2000-1 Addison Circle
Roundabout / Traffic Circle - 1997

RE: Addison Circle Phase II Public Infrastructure
Addison Circle Geometry
HZI Project No. 01-1822-21

Addison Circle East Leg Plan Review

**MODERN ROUNDABOUT
for
ADDISON CIRCLE**

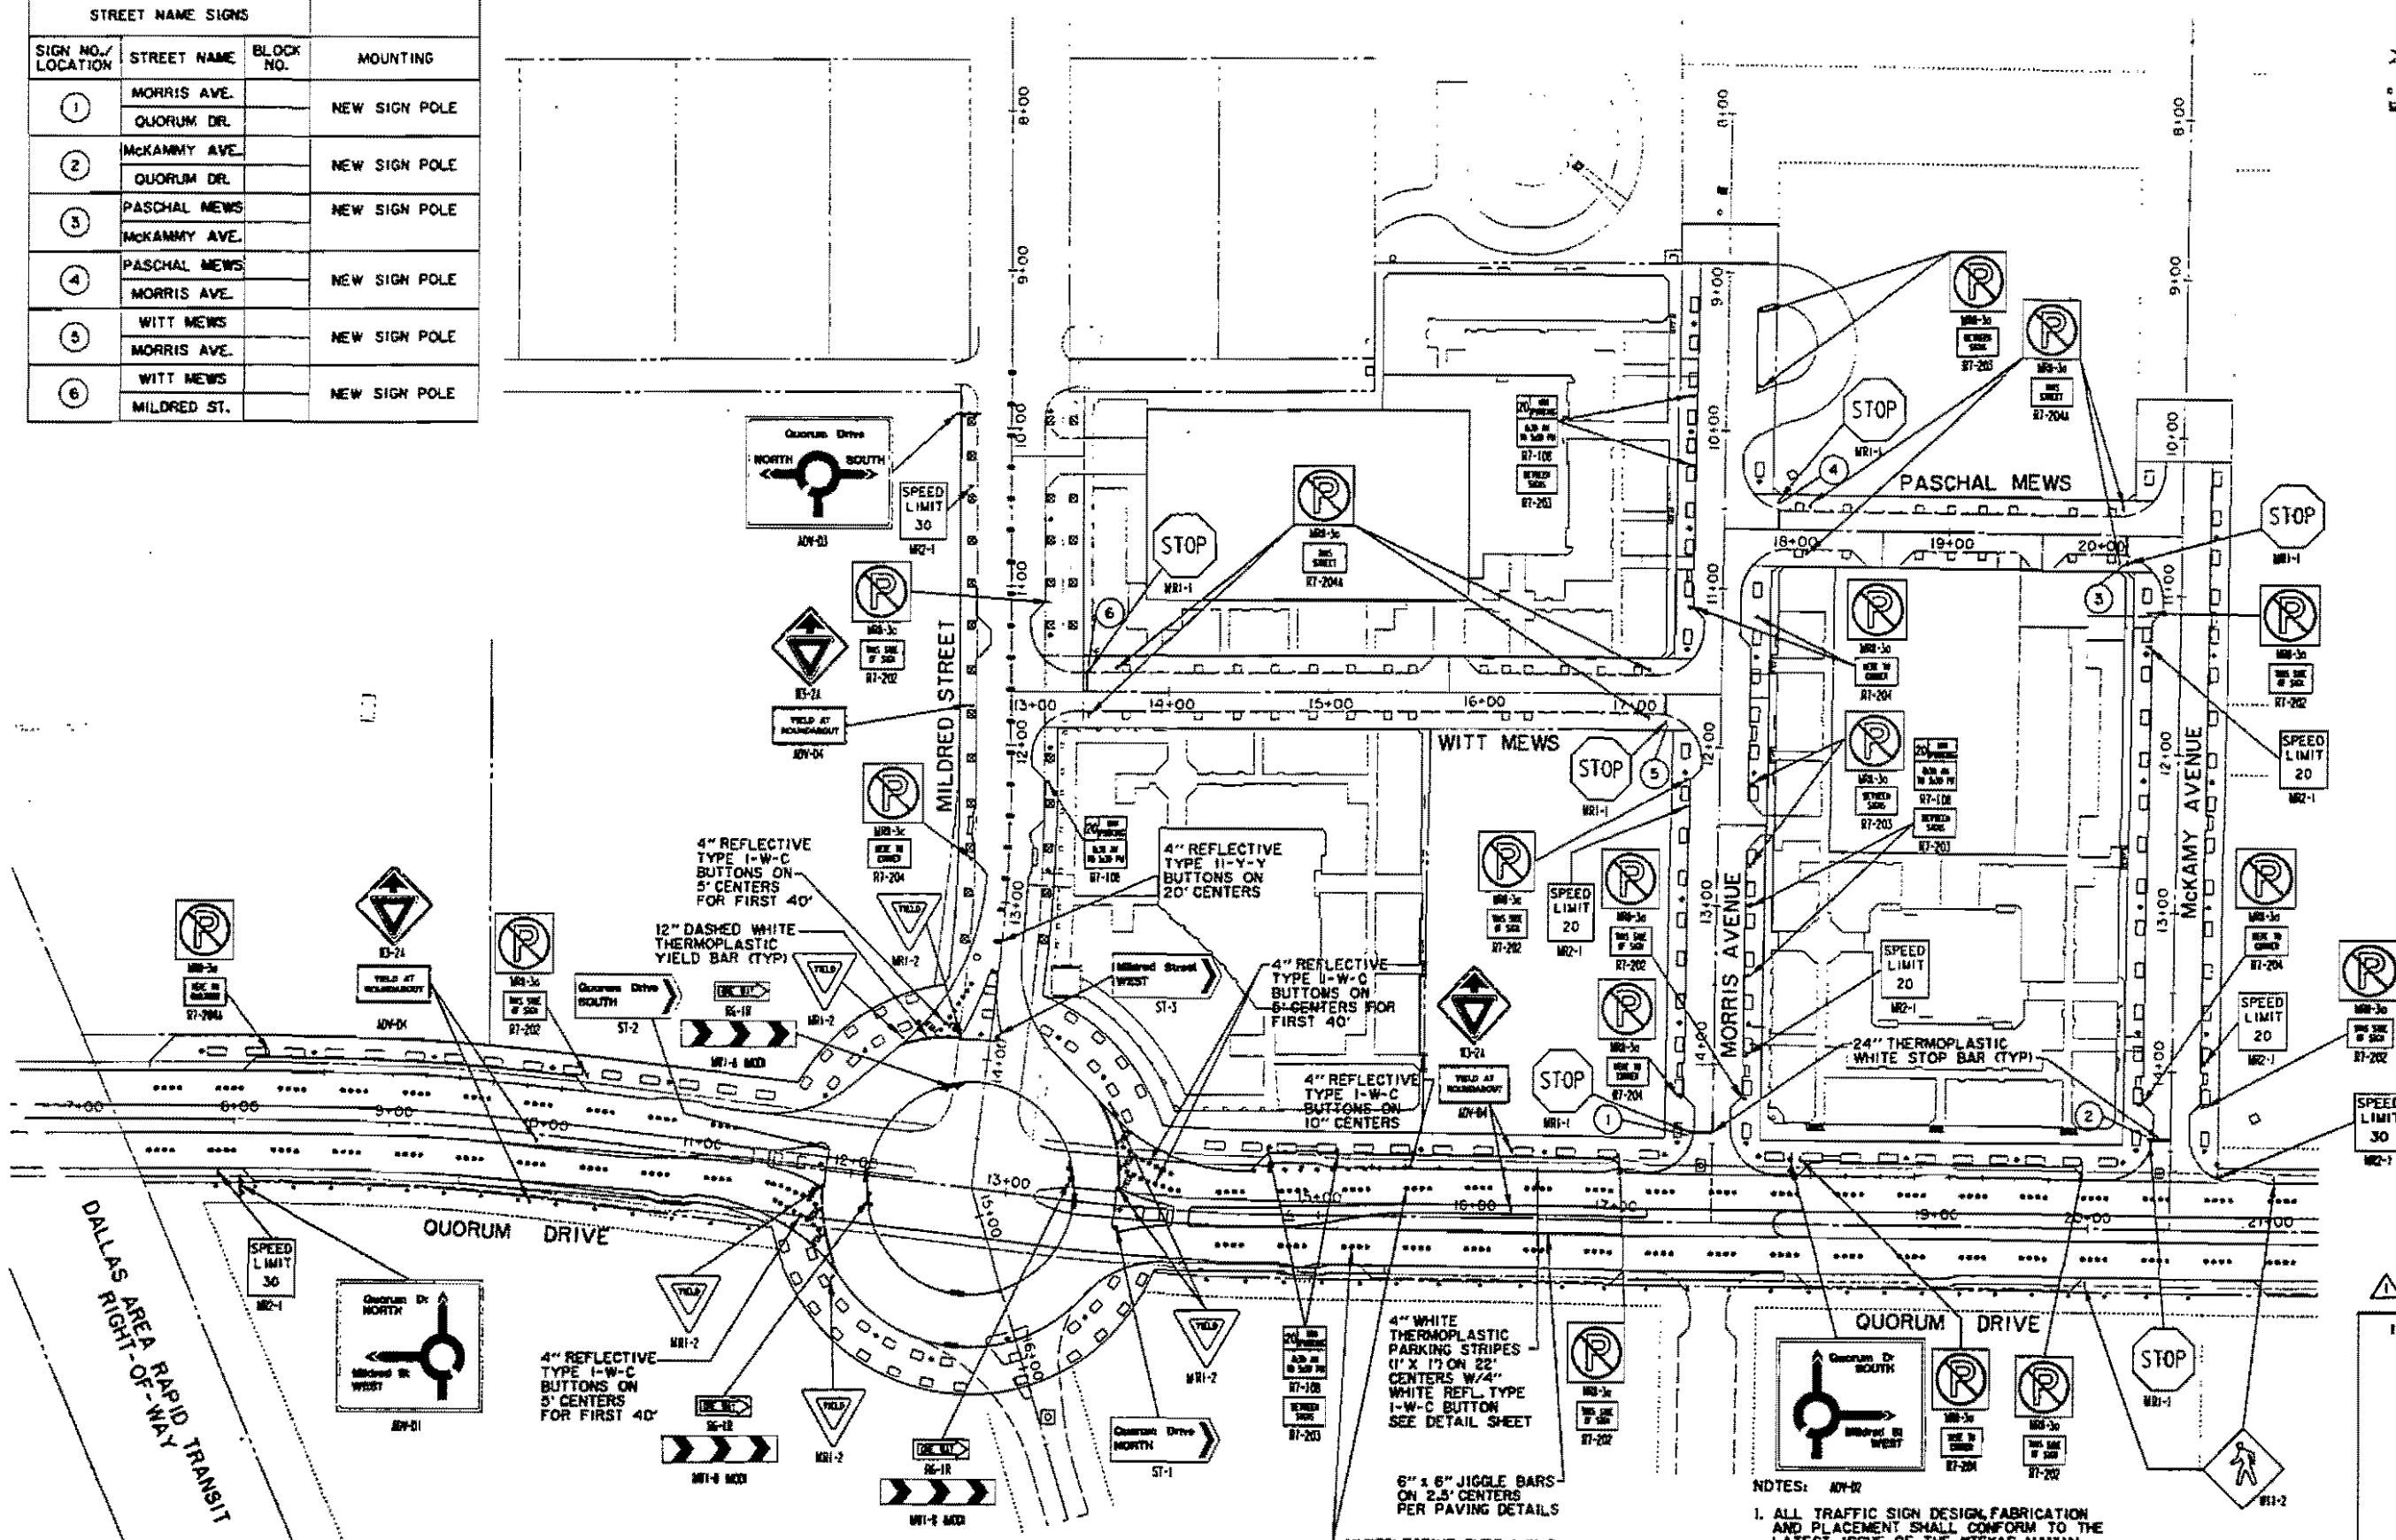
ENTIRE SHEET REVISED PER ADDENDUM #2
